STANDARDS AUSTRALIA

Amendment No. 1
to
AS 1926.3—2010
Swimming pool safety
Part 3: Water recirculation systems

REVISED TEXT

SUMMARY: This Amendment applies to the inside front cover, Clauses 2, 3.1, 4.1, 4.2, 5.2, 5.5, 6.1.3, 6.1.4, 6.2, 6.3 and Figure 1.

Figure 1

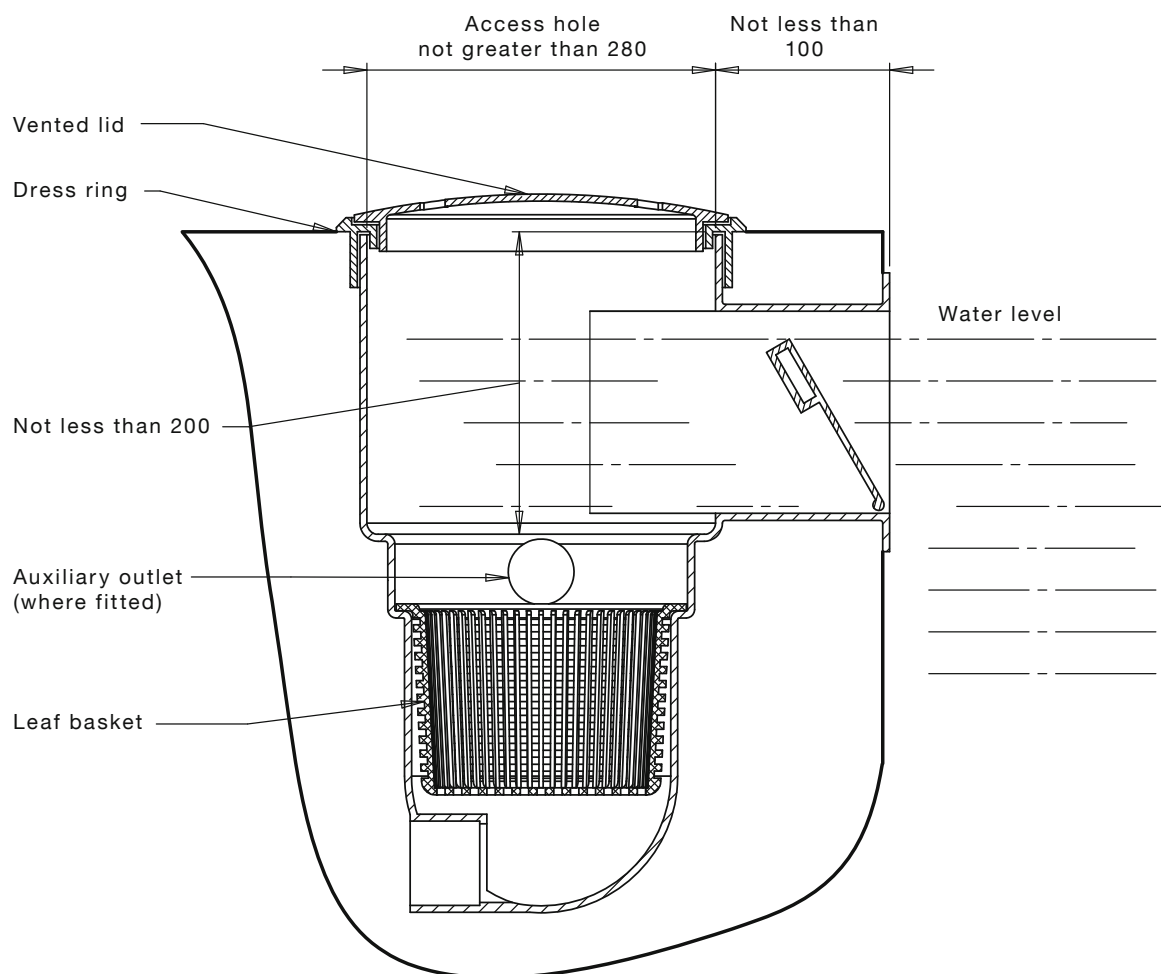
Delete the Figure and replace with the following:
